AN TAISCE LIMERICK

SUBMISSION ON DIRECT PLANNING APPLICATION BY LIMERICK CITY & COUNTY COUNCIL TO AN BORD PLEANALA UNDER SECTION 175 of the Planning and Development Act 2000, for the redevelopment of the c. 2.35 Hectare 'Opera Site' in Limerick City Centre.

RE: ABP Ref No. 304028

Figure 8: Model photograph from developer's planning documentation showing Parcel 6 replacement building on Granary section (upper right section of picture) completely dwarfed by both the tower block building and other new buildings in the proposed development.

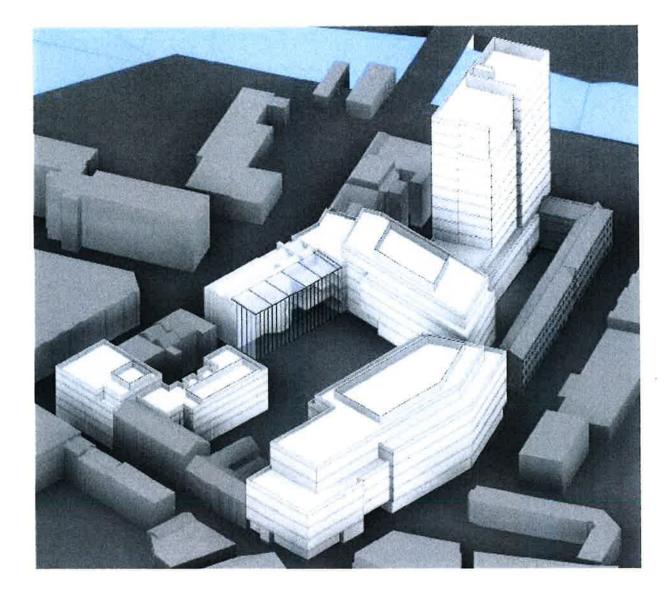
Apart from the construction of large buildings, the proposal involves the demolition of perfectly sound, functional, inoffensive existing buildings for no apparent reason and for which no justification has been provided. For example, the existing extension to the Granary Building which currently houses the City Library is to be demolished to make way for another building of the same height but not as aesthetically attractive as the existing building (Parcel 6 of the proposed development). This approach by the clearly spendthrift developer defies logic and common sense and is contrary to the proper planning and sustainable development of the area.

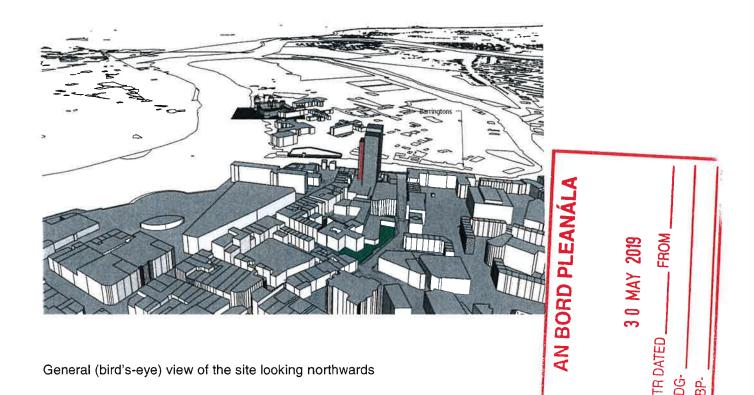
An Taisce notes the proposal to repave the streets bounding this site in concrete aggregate paving. The applicant gives the public footpath on William Street as an example of the type of material proposed. William Street was remodelled over the period 2010-2012 but since then the paving has not proven to be particularly durable. It is highly prone to staining and weathering which in turn necessitates frequent deep cleaning. Many of the paving flags have cracked and broken, particularly on Sarsfield Street where ugly cement has been used to patch and repair.

An Taisce is of the view that such poor quality paving is entirely inappropriate and that natural stone should be used instead.

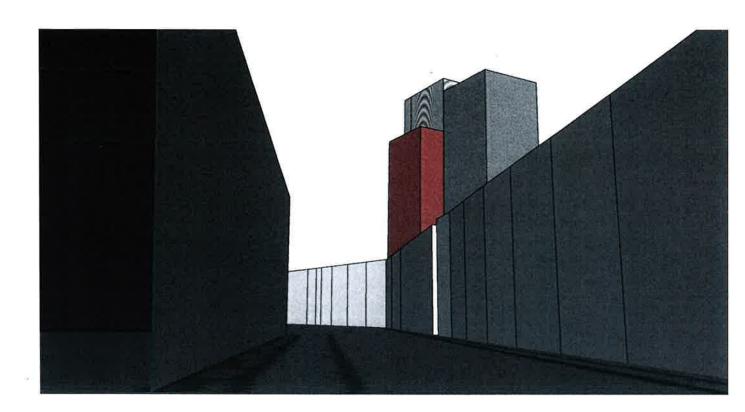
At midday the sun is at its zenith, it is at its most intense and powerful, casting its least shadow on those below. Thus, we would respectfully submit that presenting midday shadow data is a waste of both time and ink.

Wording and images for residential shadow study are also deceptive. Fig 79-81 on residential on MIchael St is a 3 hour study. These properties will receive no sun after 3 pm throughout the year. Such a significant characteristic should be described accurately and are not "minimal" as frequently described throughout this documentation

A BRE Guidance document is frequently mentioned, and states its recommendations are 'generously met', but no specific publication or standard is stated and no instance of specification of such generosity given. Most importantly, as in Fig 35 and 36, illustrating the massing of the tower to the Granary, seventy five per cent (75%) of the tower is not shown in either image.

Scaled rendering view from human eye-level at Hunt Museum to Bank Place houses and proposed tower blocks

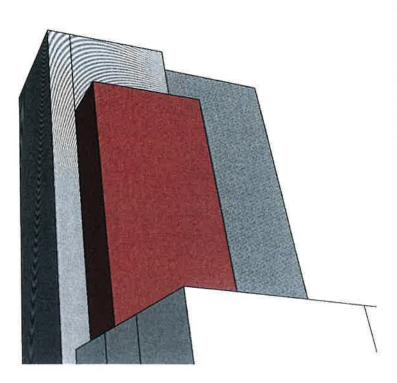
If ever there was a building 'out of place' this is it. Standing alone, isolated from the city's other high rise buildings, specifically those located between Shannon Bridge and the Docks, the proposal seems incongruous and eccentric. (It might be suggested that in that high rise quarter, where publicly owned building land has recently become available, that the proposed tower might be more appropriately sited.)
